MFN 05-153
Supplement 1

**Subject: Response to NRC Request for Additional Information Letter No. 1
Related to ESBWR Design Certification Application – Radiation
Protection – RAI 11.5.3-3 – Supplement 1**

RAI 11.5.3-3 – Supplement 1

Figure 11.5-1. Location of Radiation Monitors

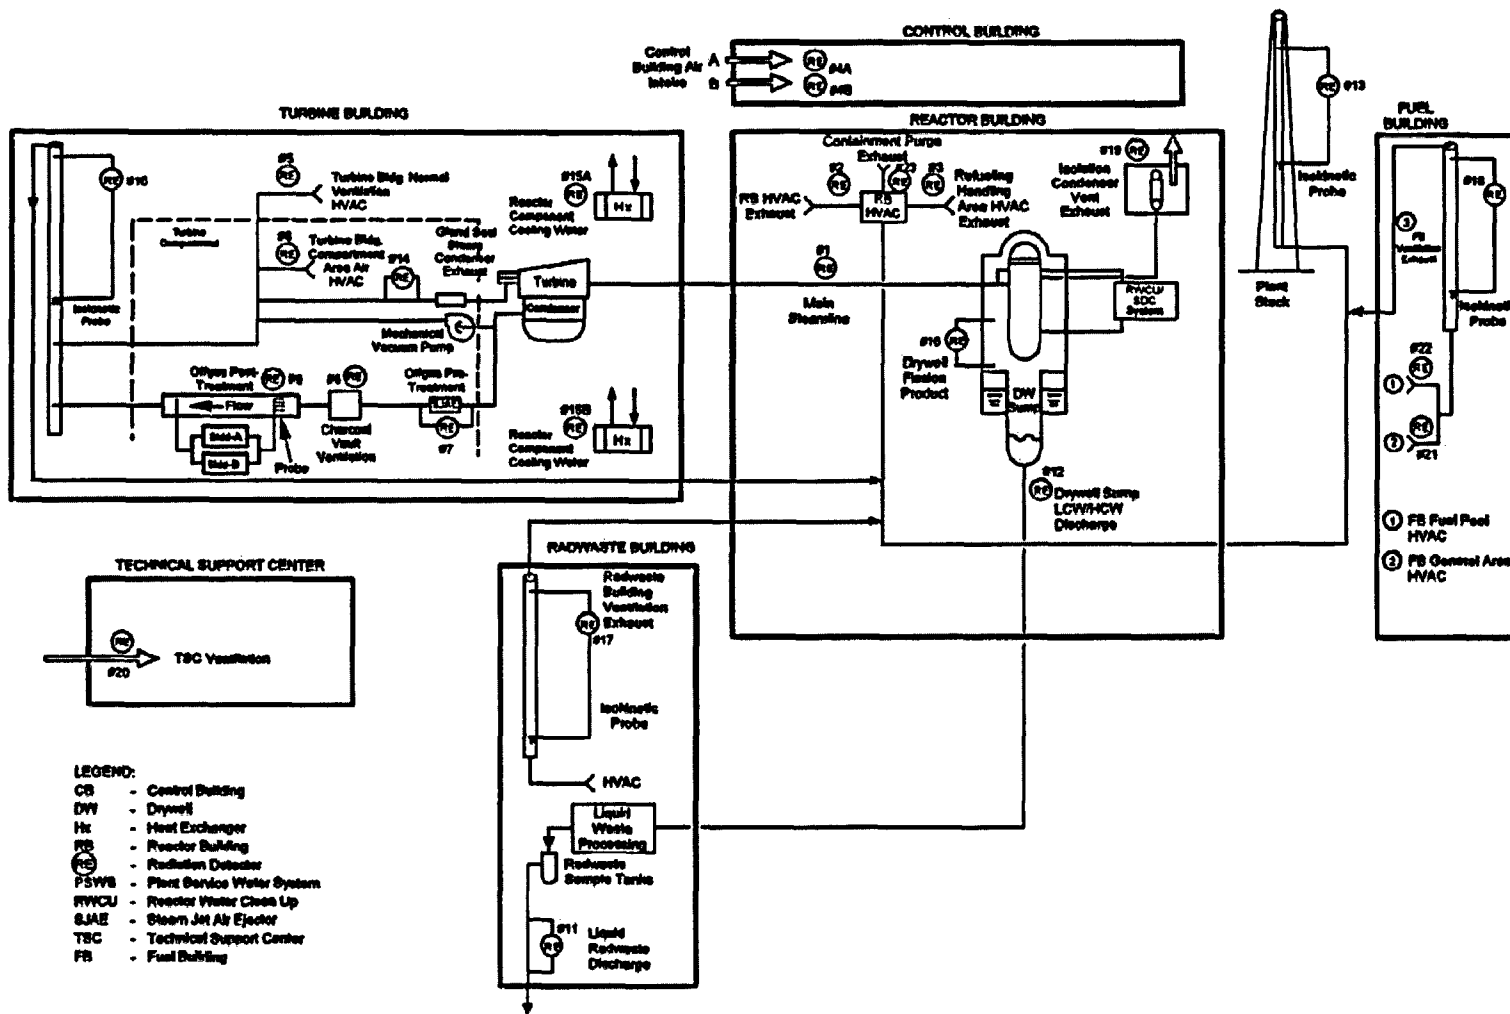
The designation of radiation monitoring systems and their respective ID codes are inconsistently presented in Table 11.5.3 and Figure 11.5-1. This section refers to Table 11.5-3 and Fig. 11.5-1 for information about the designation and ID codes of radiation monitoring systems. A review of instrumentation ID codes indicates that the numbering system is inconsistent for ID No. 21, 22 and 23. The system identified as No. 21 on Fig. 11.5-1 is not listed in Table 11.5-3 and its designation ("#21, COPS") and function are not described in the Section. As a result, ID codes No. 21 and 22 presented in Table 11.5-3 are not consistent with those shown in Fig. 11.5-1. Also, instrument ID code No. 23 is missing in Table 11.5-3, but is included in Fig. 11.5-1. Provide figures and tables (and text as needed) with updated information.

Figure 11.5-1 - Location of Radiation Monitors

- a. Provide an explanation (footnote) as to how and where do discharges from the Isolation Condenser Vent Exhaust system tie into the Reactor Building HVAC system.
- b. Update drawing to show that the Offgas Post-Treatment RMS is equipped with an isokinetic probe - such as shown for the Turbine Building, Fuel Building, Radwaste Building, and Plant Stack.

DCD Chapter 11, Revision 1 corrected Figure 11.5-1 so that COPS is not shown and the numbers are adjusted, so that reference to COPS is eliminated.

The Isolation Condenser / Passive Containment Cooling (IC/PCC) pool is vented to the atmosphere as shown in ESBWR DCD Figure 5.1-3. It is not routed to Reactor Building HVAC. Under normal IC operating conditions, boil-off steam formed in the compartments containing Isolation Condenser heat exchangers are non-radioactive and has a slight positive pressure relative to station ambient. It is exhausted to atmosphere through large-diameter discharge vents after first passing through a large face area passive-type steam dryer. Moisture removed by the dryer from this boil-off steam is ducted back to the IC/PCC pool.

DCD Figure 11.5-1 will be revised to show the isokinetic probe for the Offgas Post-Treatment subsystem as noted in the attached markup.
